Re: Letter of Transmittal – Onondaga Lake Repository Addition

Re: SCA West Basin - Design Concepts and Operation Plan, Dated October 2013

SCA WEST BASIN – DESIGN CONCEPTS AND OPERATIONS PLAN

**Honeywell International, Inc.
Sediment Consolidation Area
Syracuse, NY**

I-30

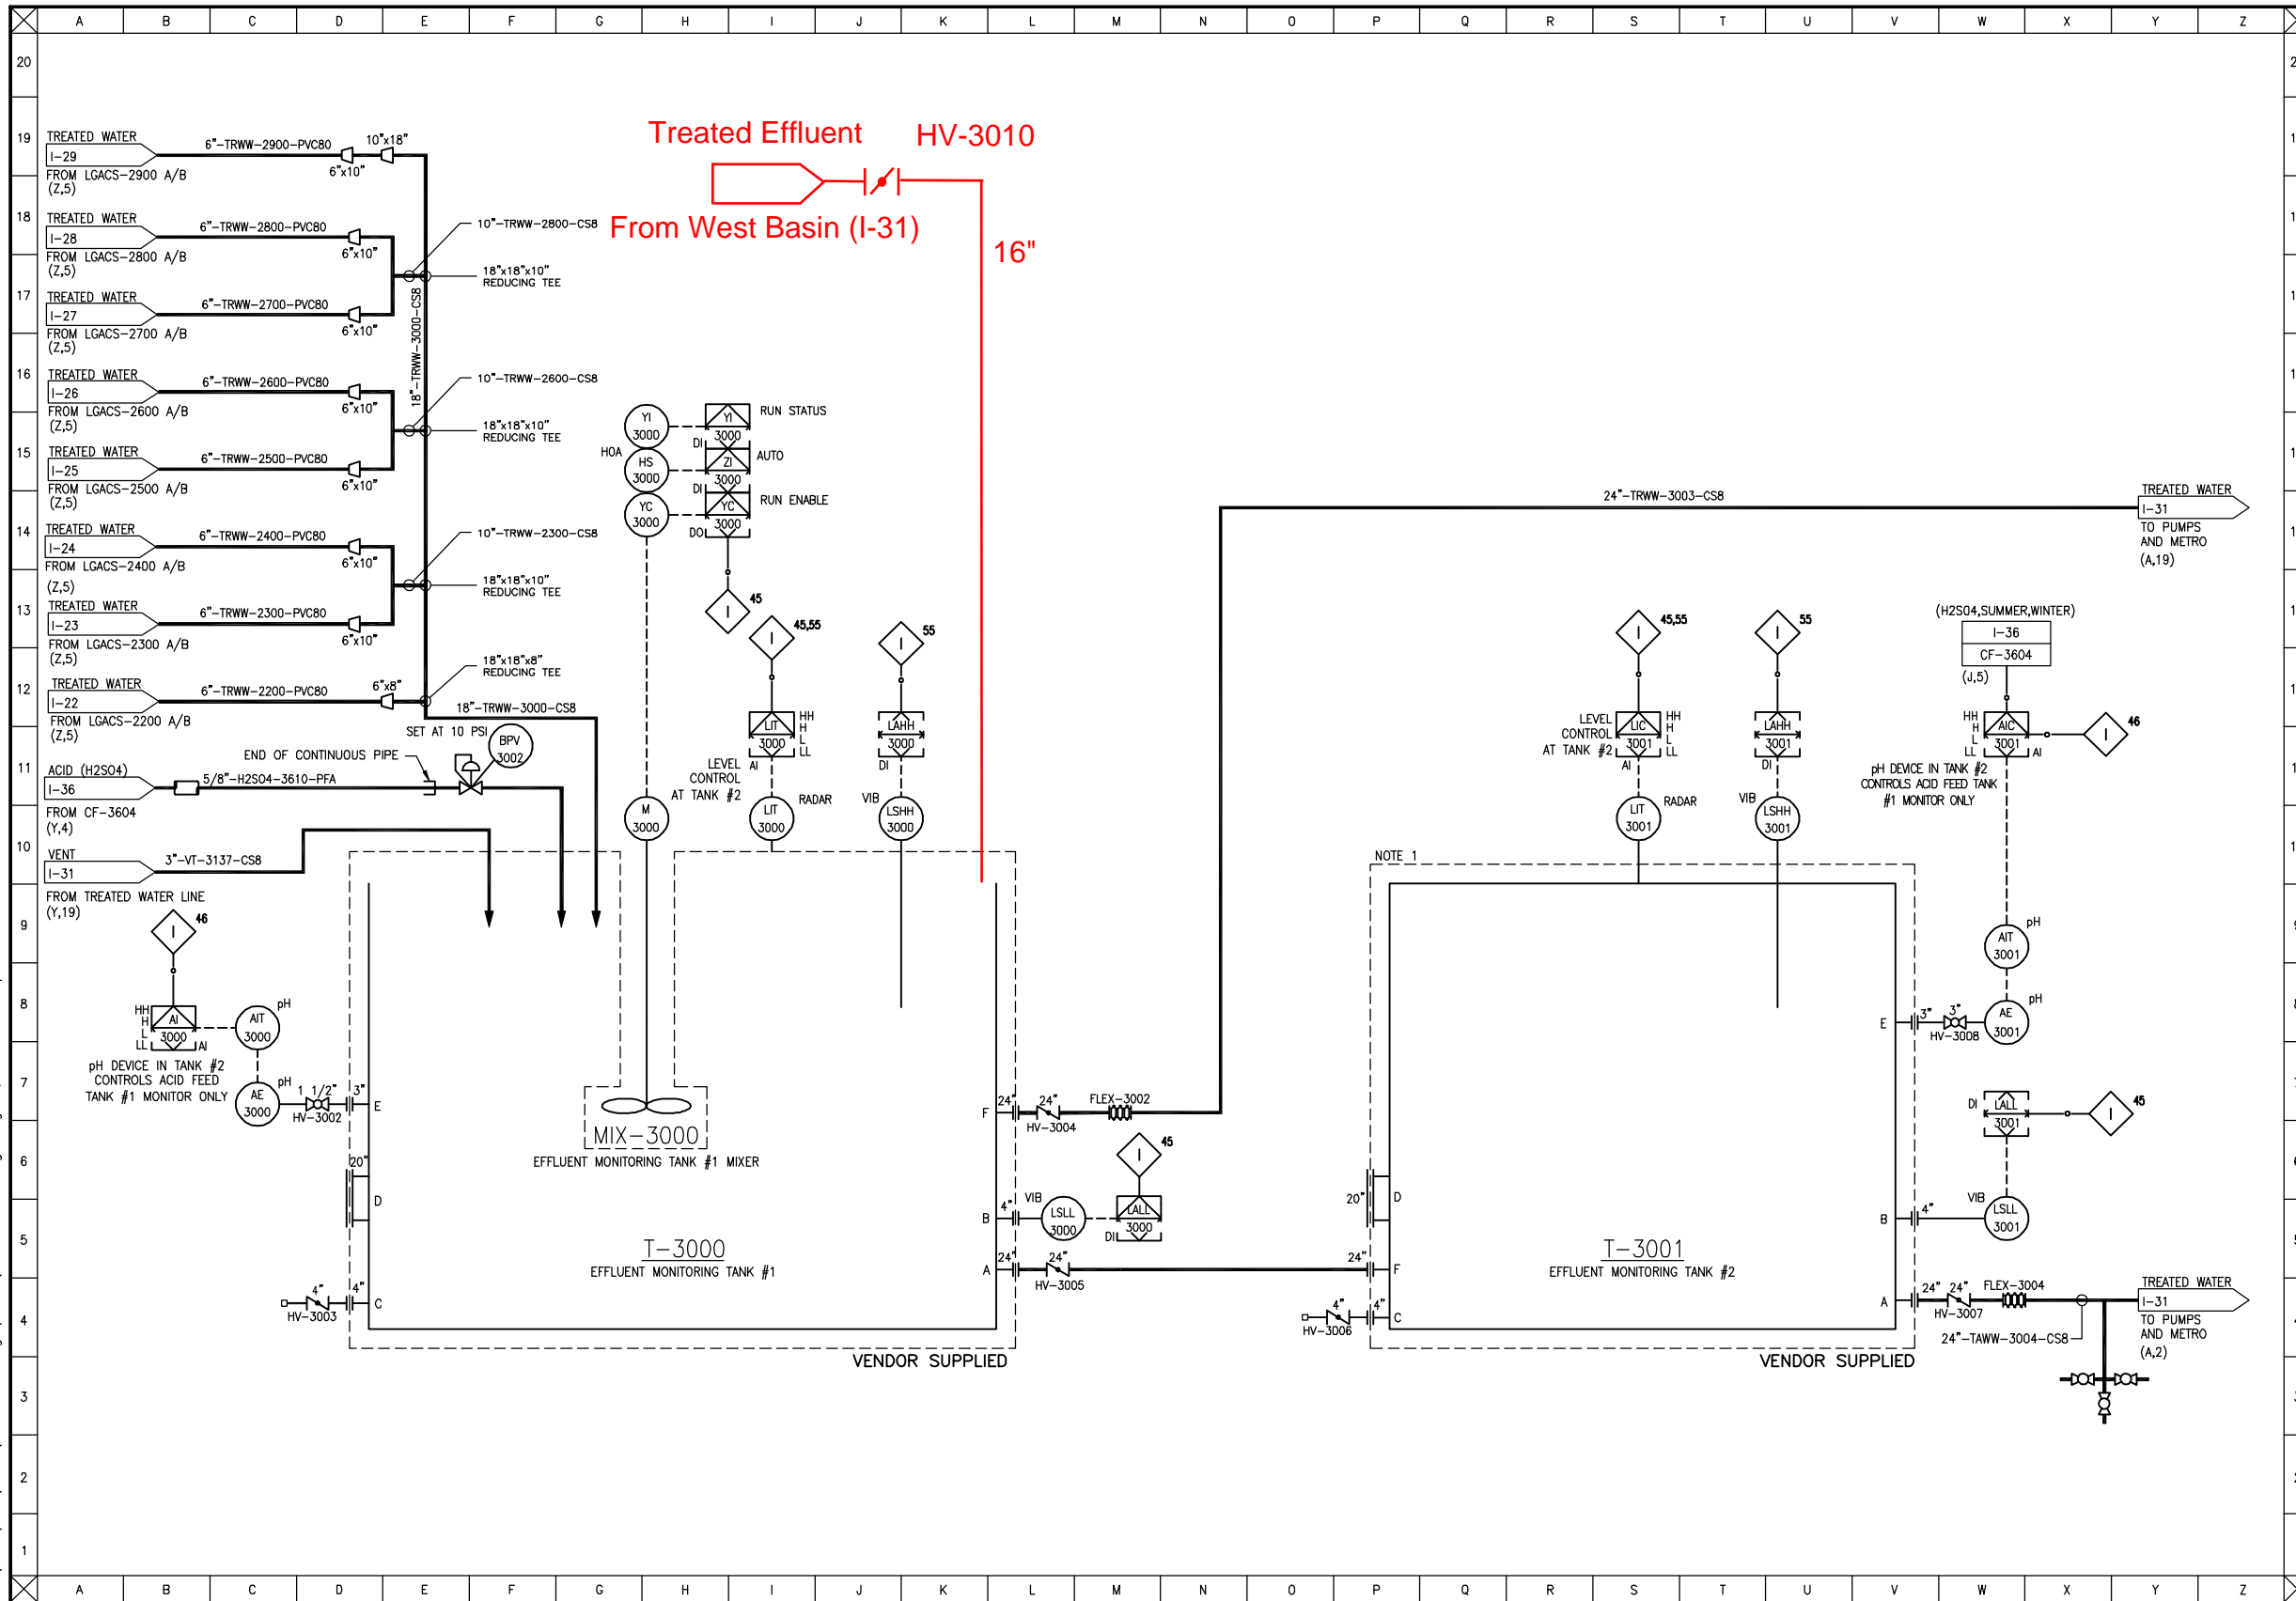
9/30/13 West Basin Modification

I-31

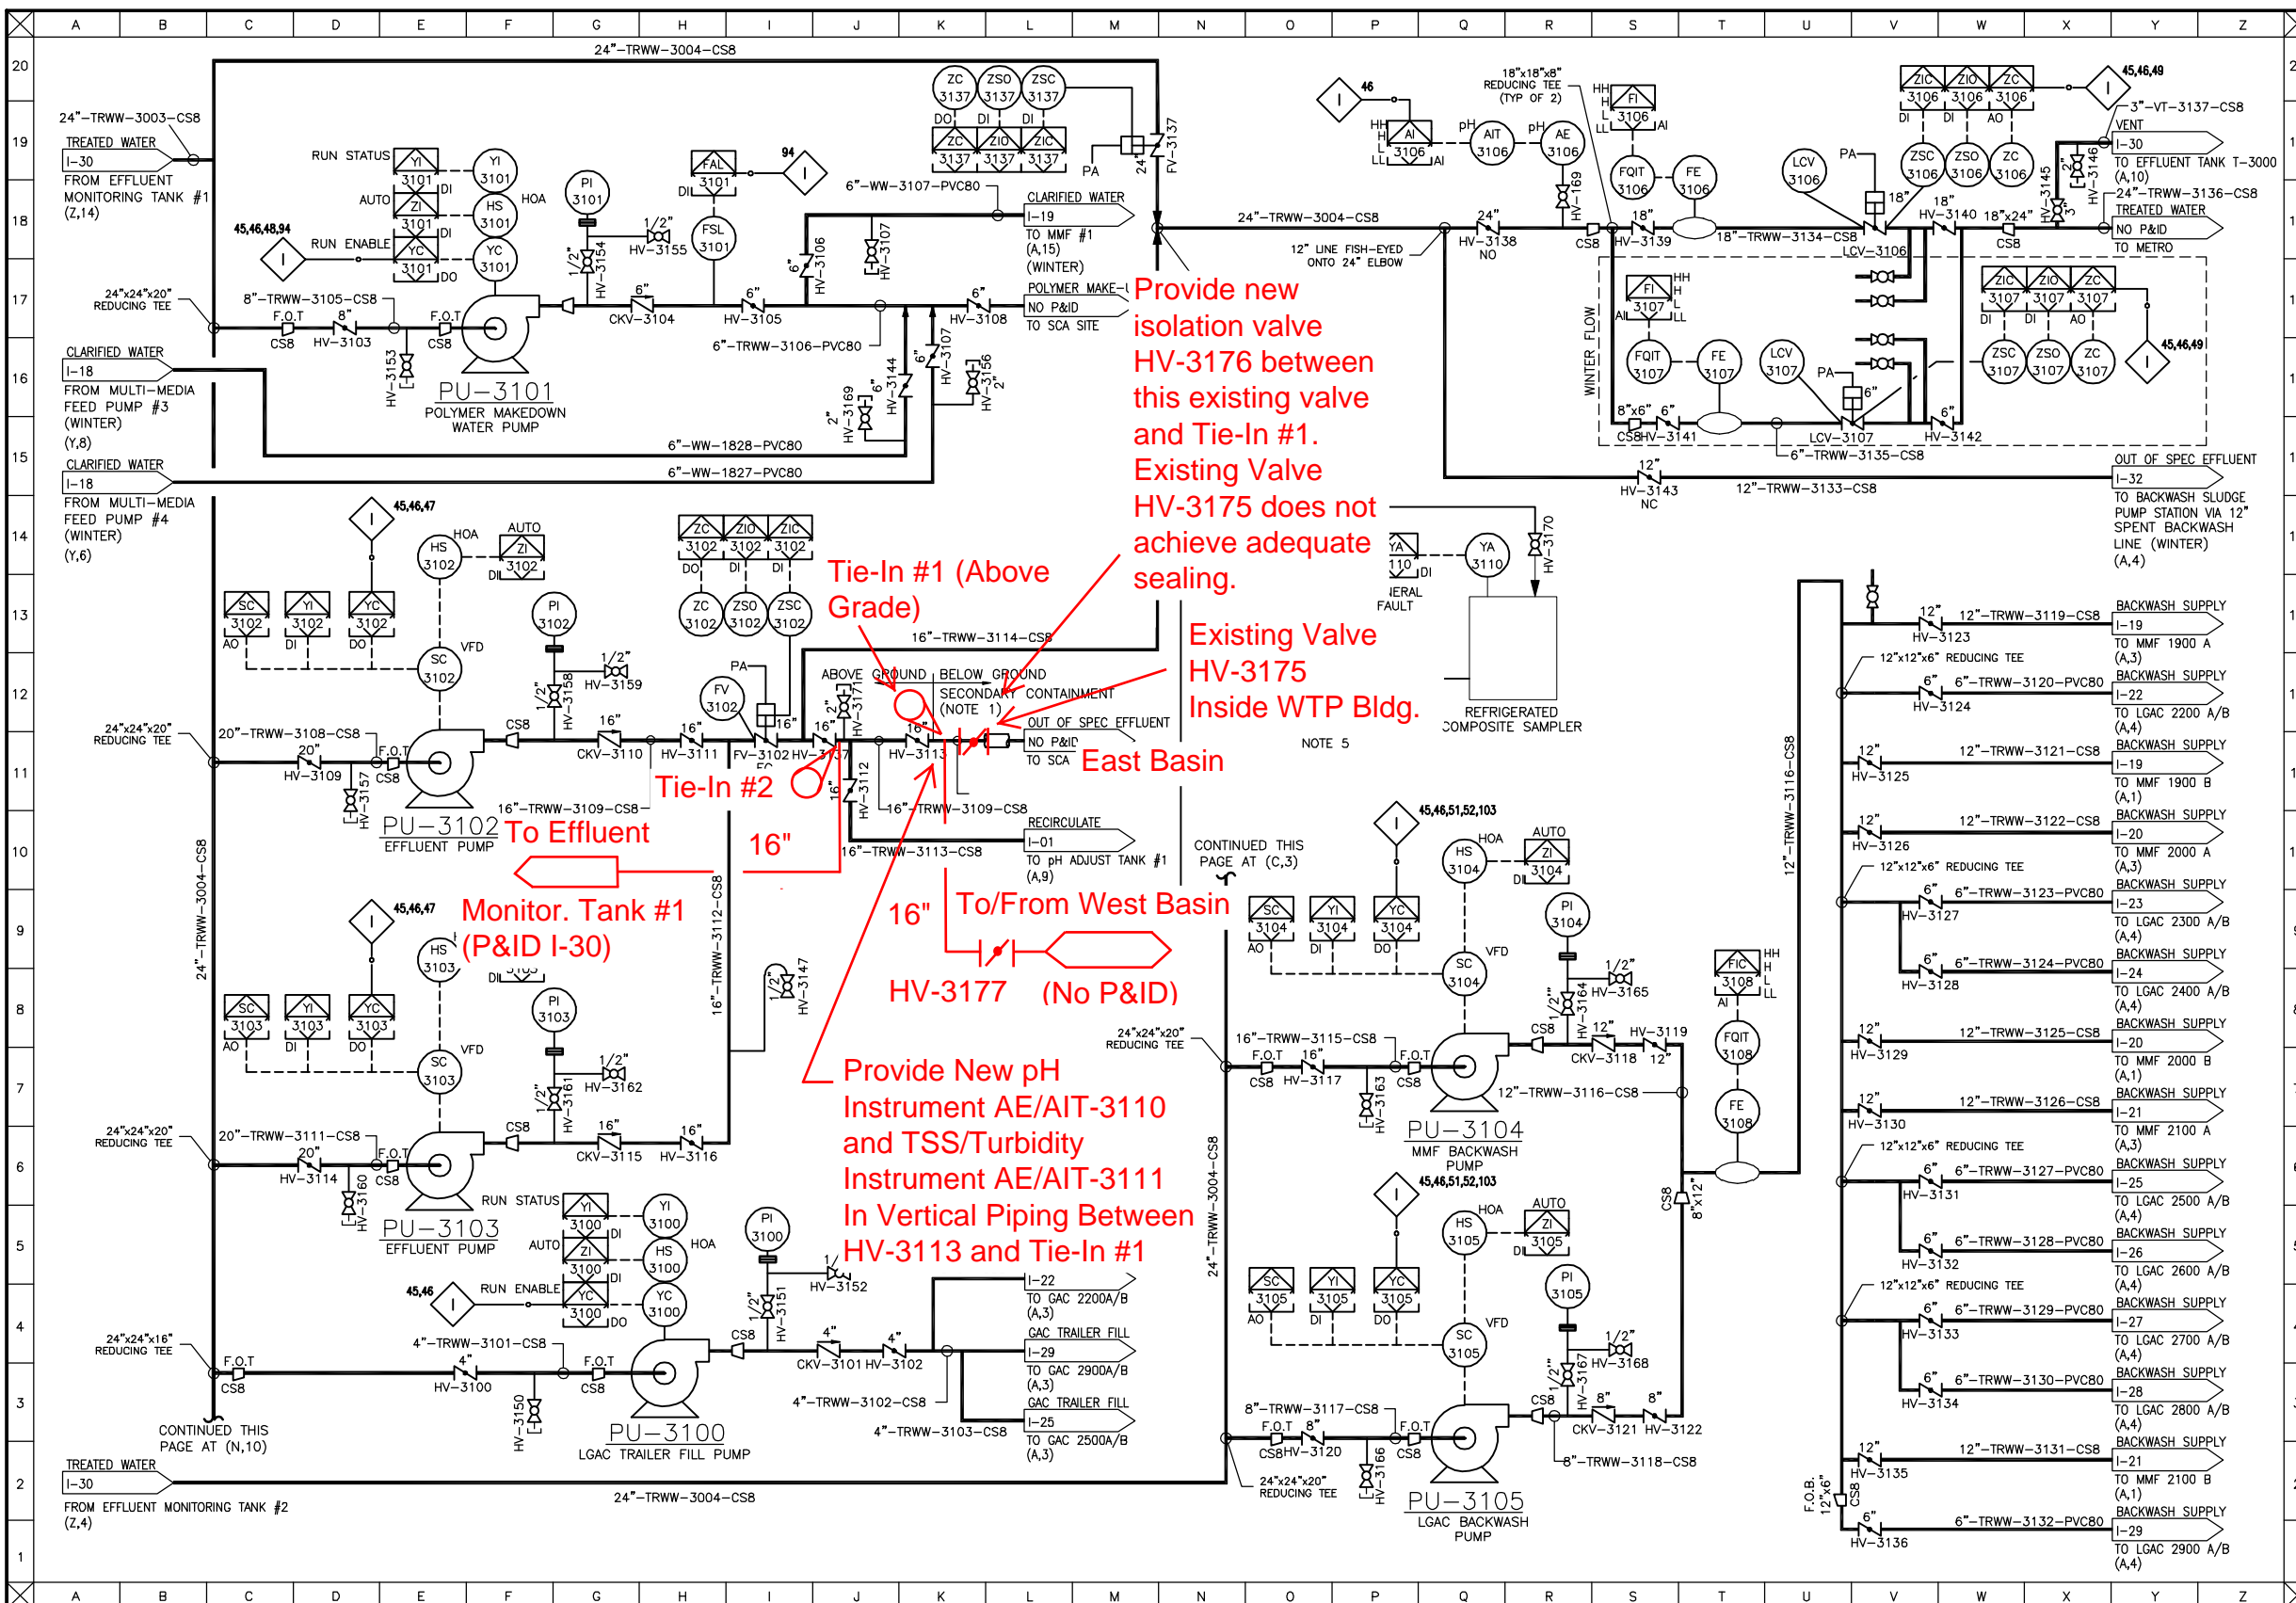
9/30/13 West Basin Modification

WTP ISOMETRIC

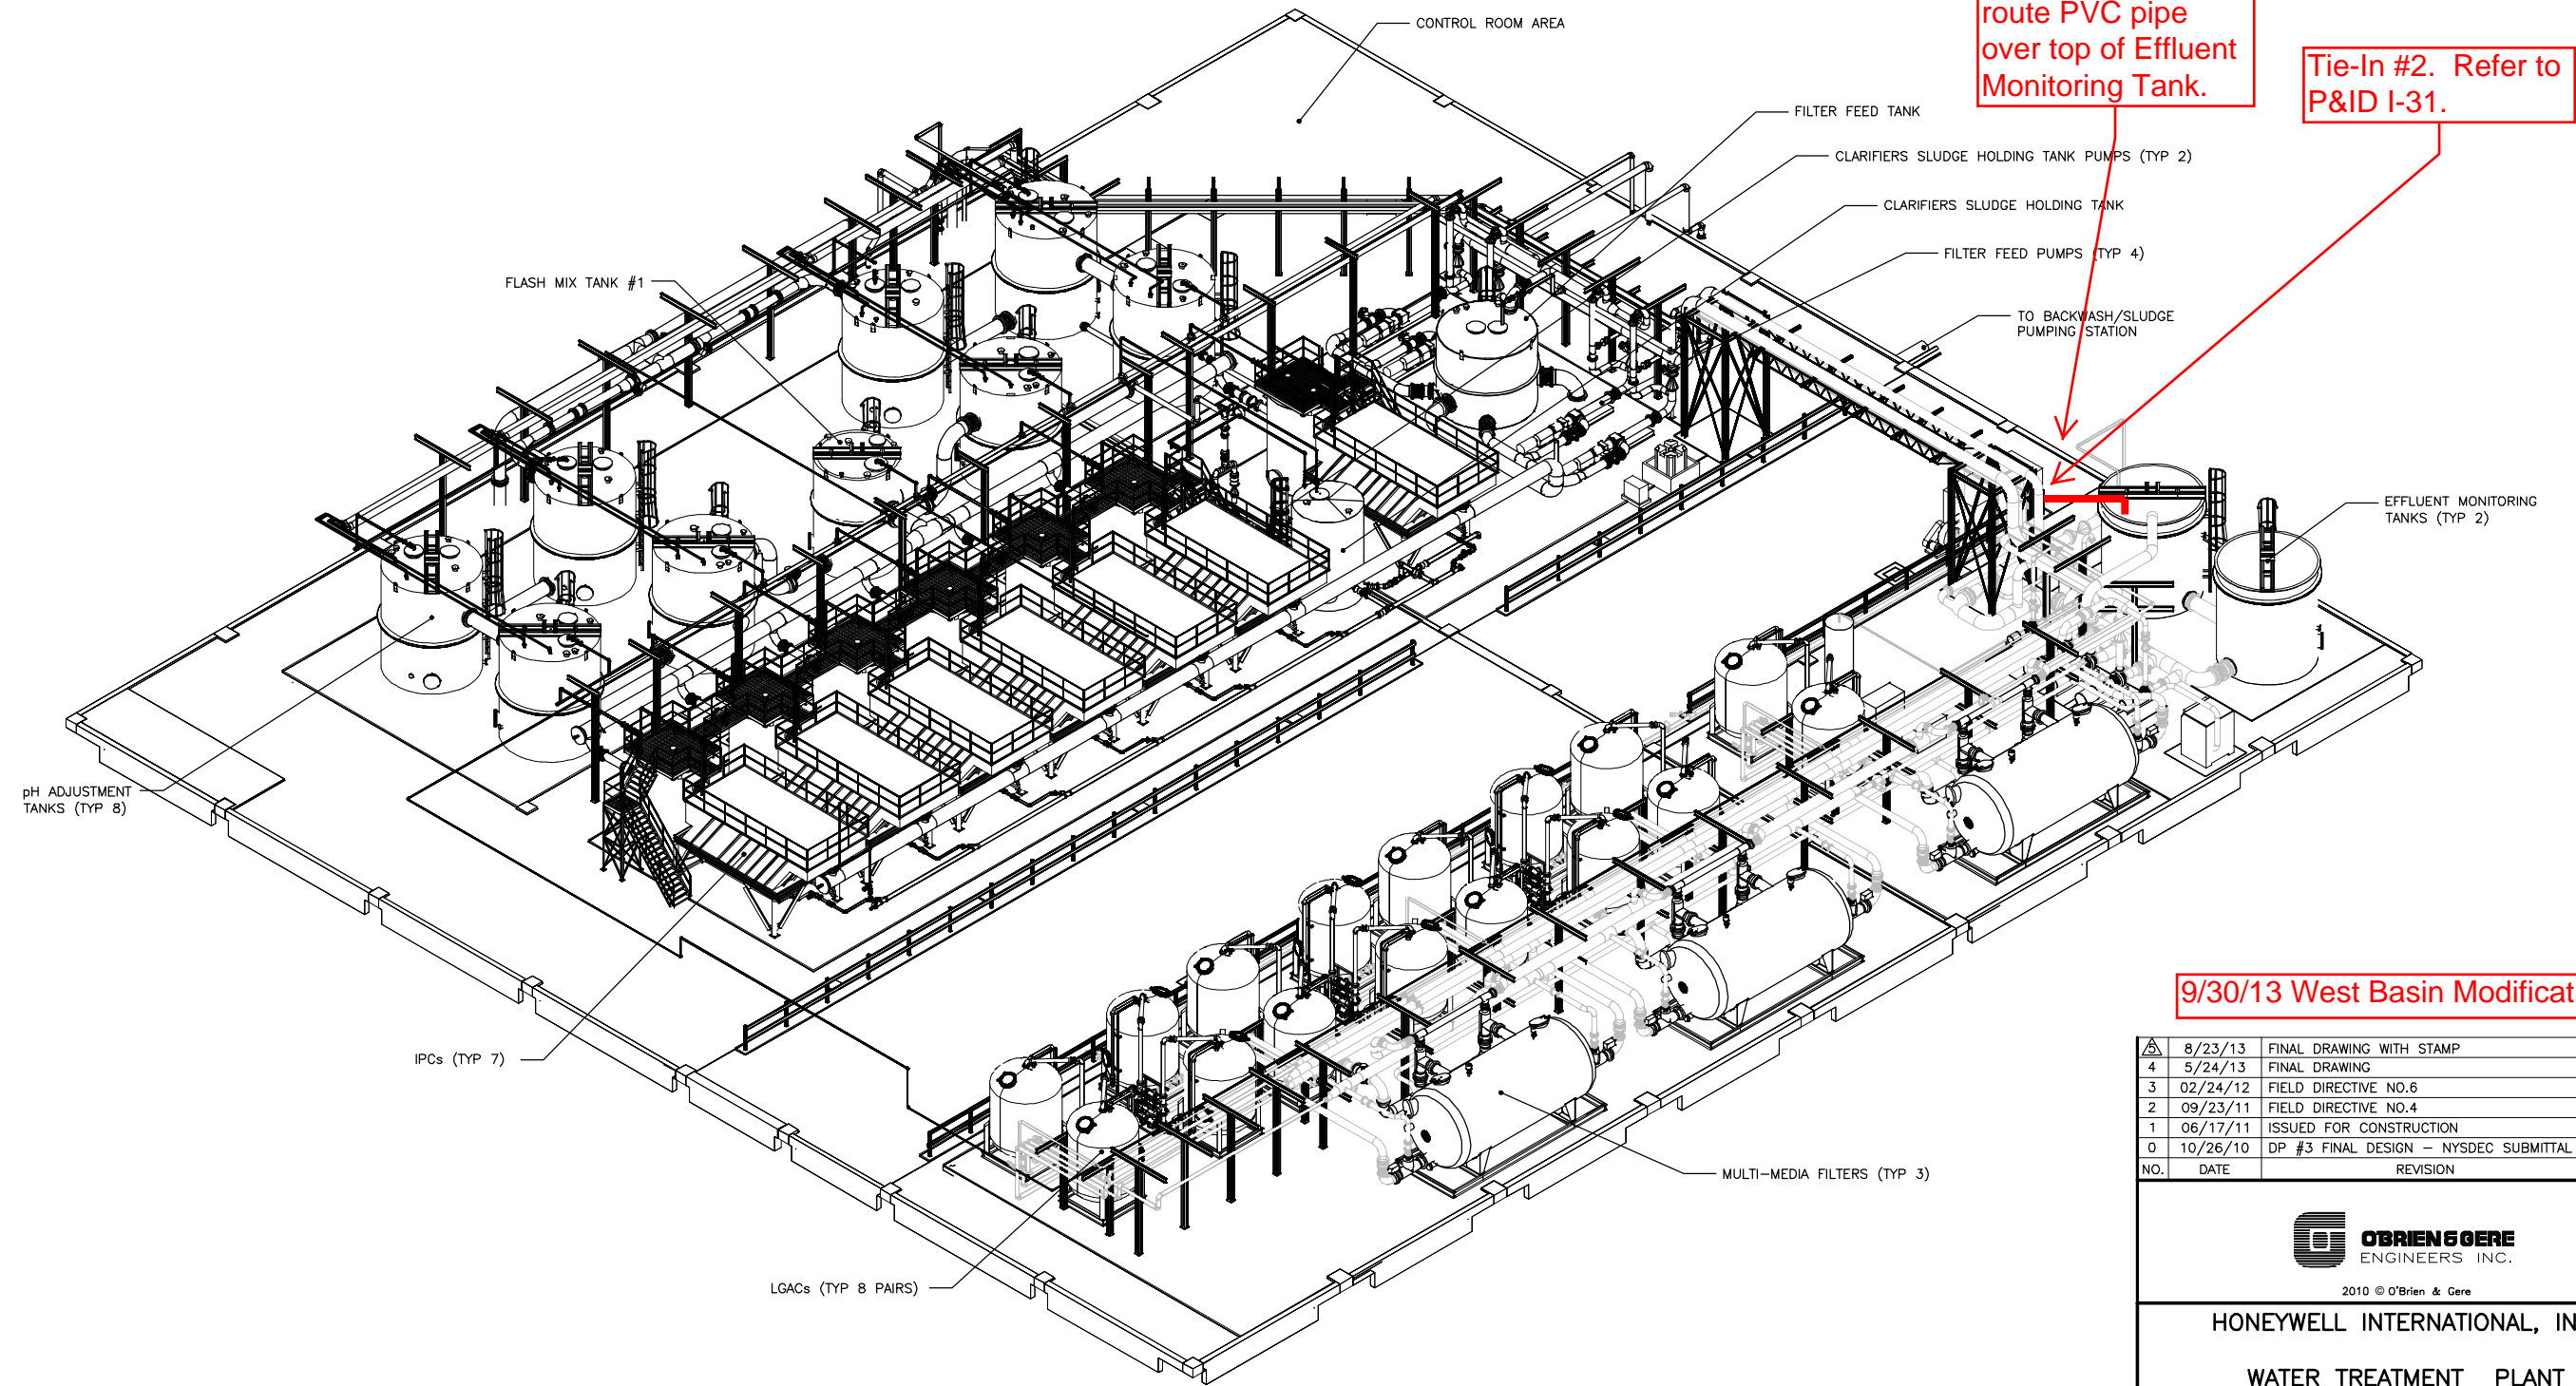
Install tee on existing treated water return line above existing valve. Add manual valve HV-3010 and route PVC pipe over top of Effluent Monitoring Tank.

Tie-In #2. Refer to P&ID I-31.

9/30/13 West Basin Modification
